CERTIFICATE OF APPROPRIATENESS

Property: 1226 Heights Boulevard, Lot 19, Block 187, Houston Heights Subdivision. The property is a 7,500 square foot (50' x 150') interior lot. The new two-story house approved by HAHC in July 2013 is partially completed.

Proposal: New Construction (Revision) – Revise COA granted in July 2013 for new two-story house to construct a 3'-8" deep covered front stoop instead of previously approved 6' deep full width front porch.

SOUTH SIDE ELEVATION

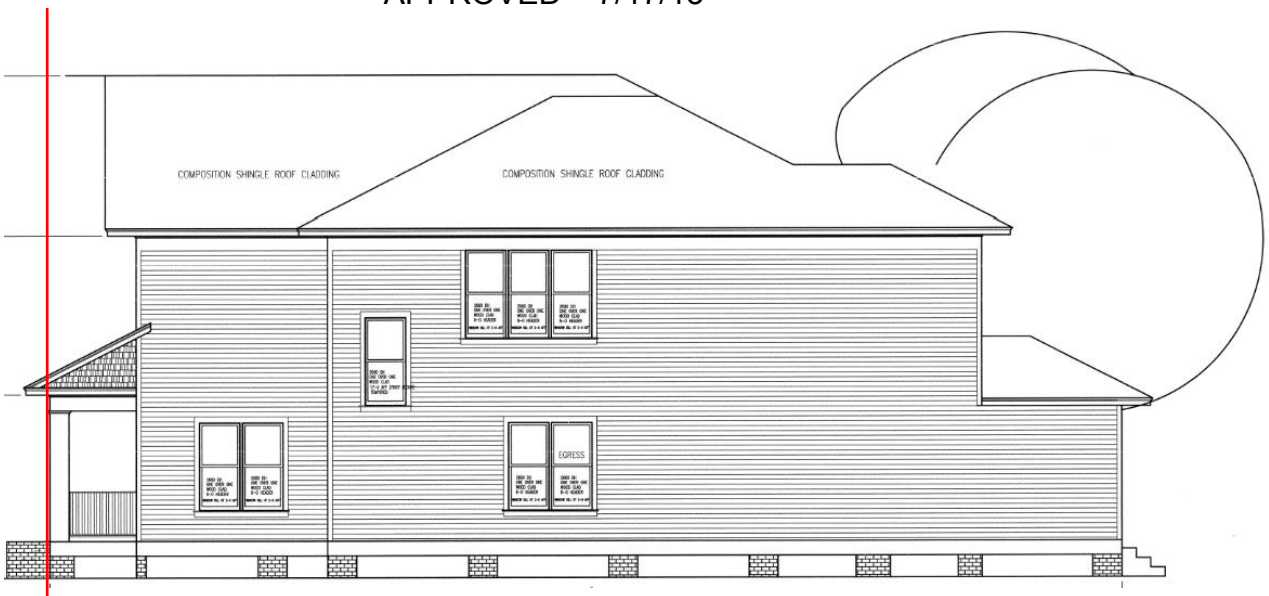
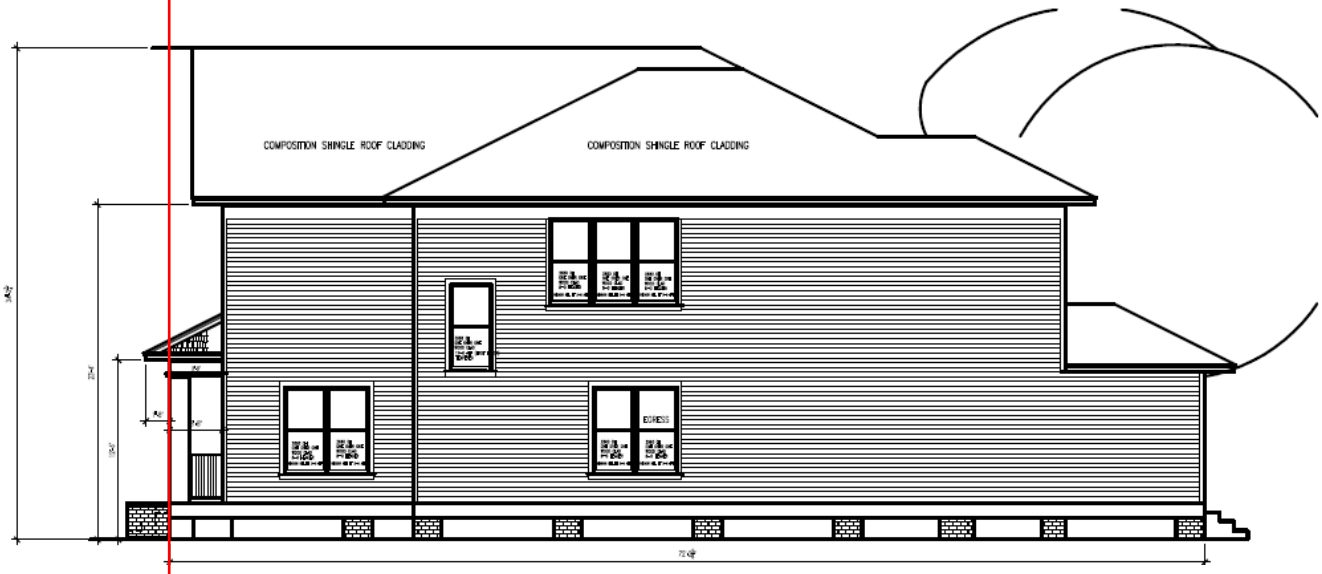
- will be set behind the required 25' front building line.
- will be flanked by brick wing walls.
- will be 11'-1½" wide and 3'-7¼" deep.
- will have a shed roof which will extend 1'-8" over the 25' building line and will have an eave height of 12'-6".
- steps will extend 3' into the 25' building line

Setbacks: The proposed covered stoop will be set behind the 25' front building line. The steps (each 1'-0" deep) will extend 3'-0" forward the 25' building line. The proposed roof will extend 1'-8" forward the 25' building line. See drawings for more detail.

STOOP DETAILS

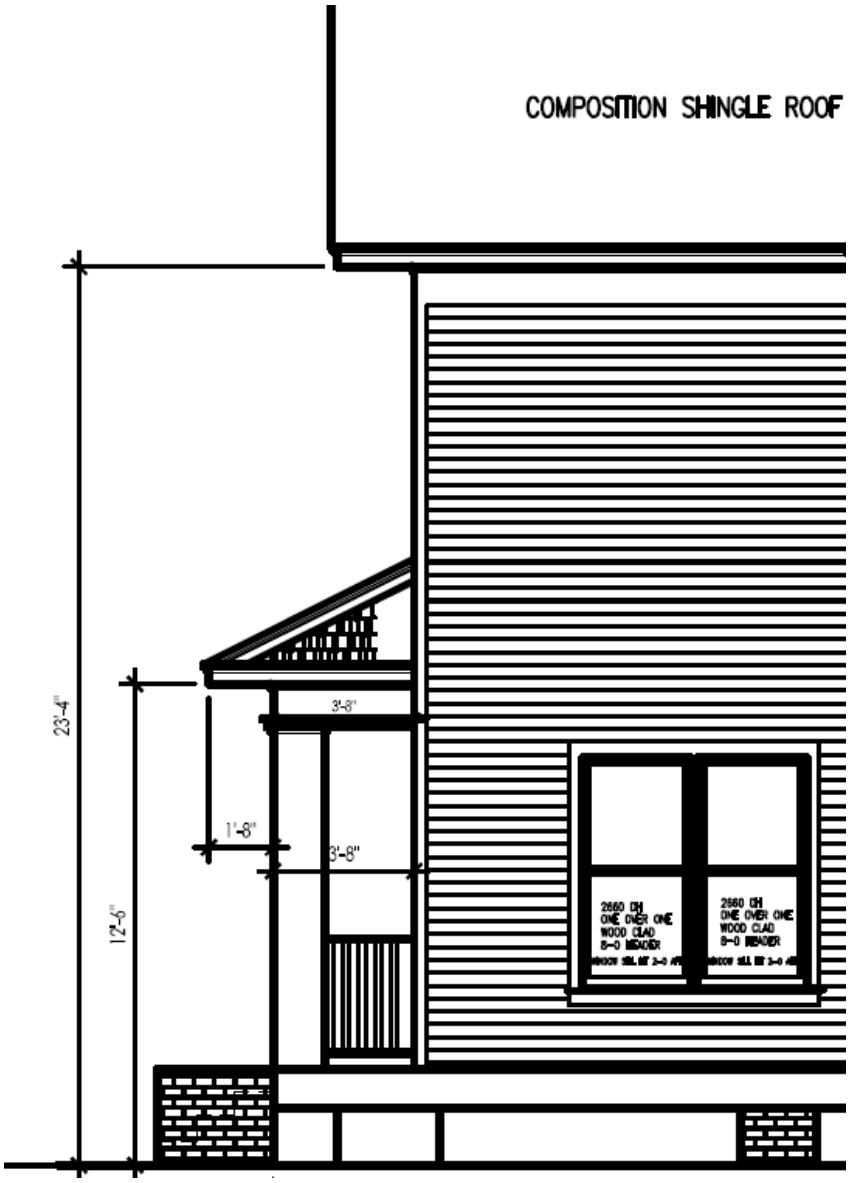
Shape/Mass: The proposed covered stoop will be 11'-1½" wide and 3'-7¼" deep. The stoop will be located on the southern portion of the front wall on the façade. Three wood steps will extend from the stoop and will be flanked with brick wing walls. Two 1'-4" square columns, located at each end of the stoop will support the roof. A 3'-6" tall wood railing will be installed. See drawings for more detail.

Exterior Materials: The stoop will feature a wood floor, railing, cornice, header, and steps. The columns will be clad in smooth cement board. The wing walls flanking the steps will be brick. See drawings for more detail.

Roof: The proposed stoop will be topped by a composition shingle shed roof. The proposed stoop roof will have an eave height of 12'-6". See drawings for more detail.

DENIED OPTIONS AUGUST 2014

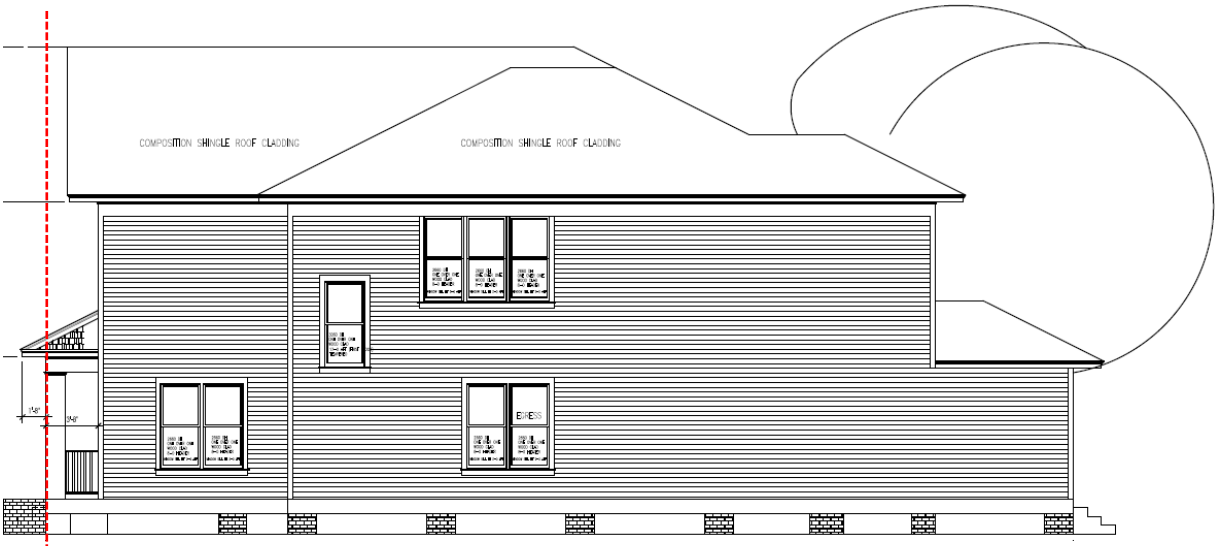
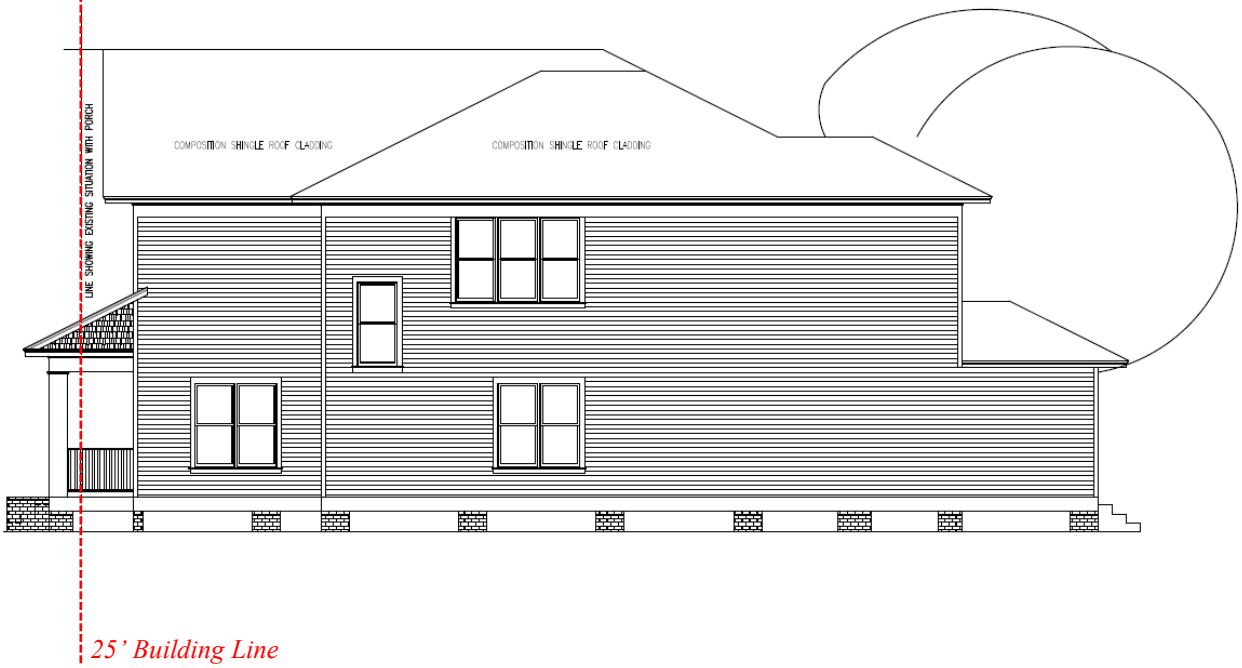
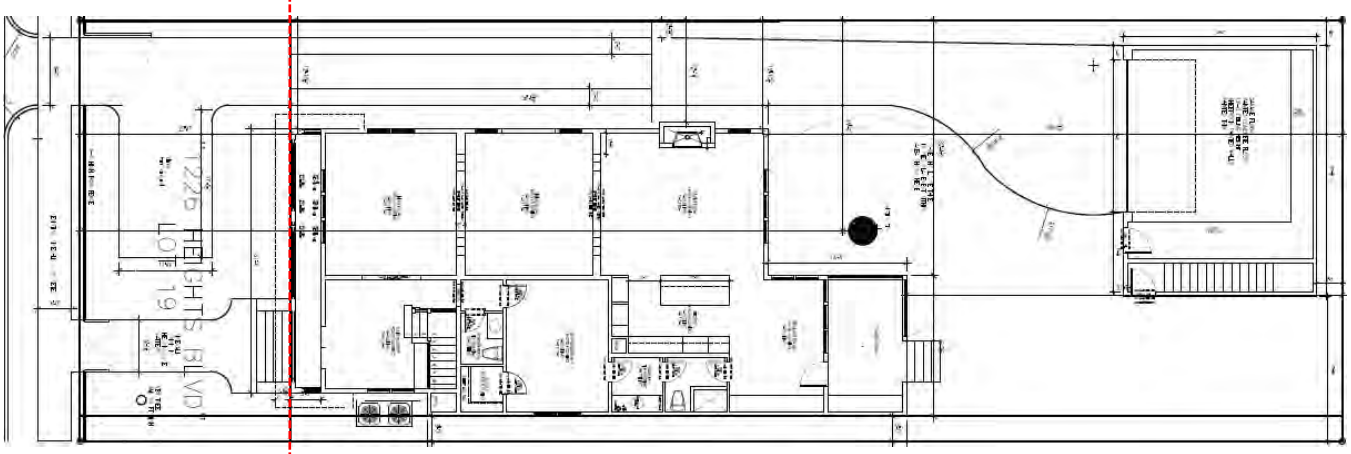
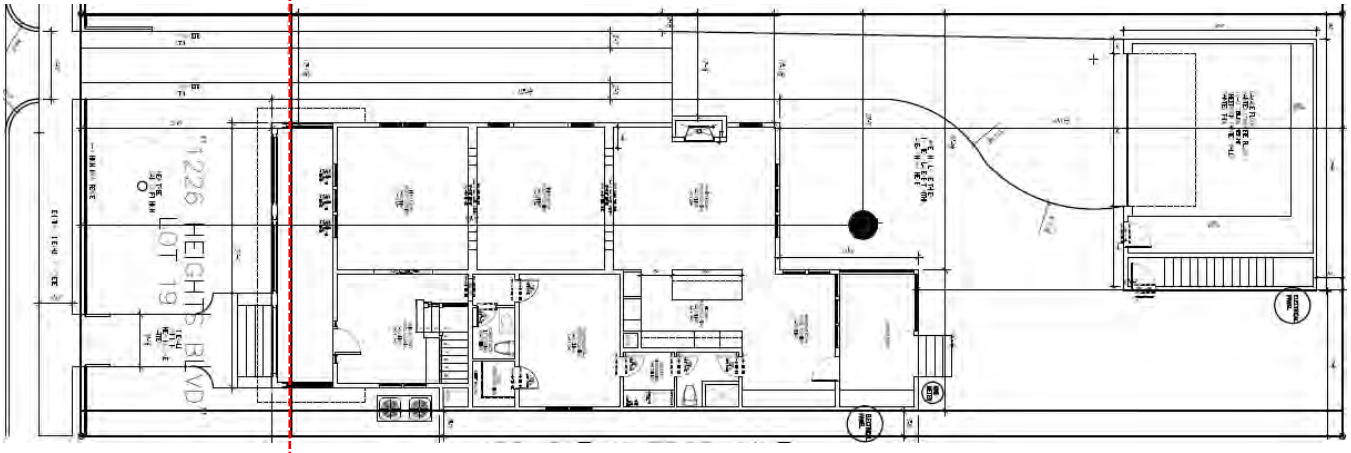
In July 2014, the owner applied for a front building line variance that was denied by Planning Commission. Additionally, two options for a revised front porch design were denied in August 2014 by the HAHC. These two options included: 1) Reduce porch depth from 6' to 3'-8" so as not to extend past the required 25' building setback line; or 2) Reduce front setback from 25' to 22.8'. Option 1 featured a porch depth that was not typical, while Option 2 featured a front setback that was not typical. On appeal to the Planning Commission, during the September 19, 2014, meeting, the HAHC denial was upheld.
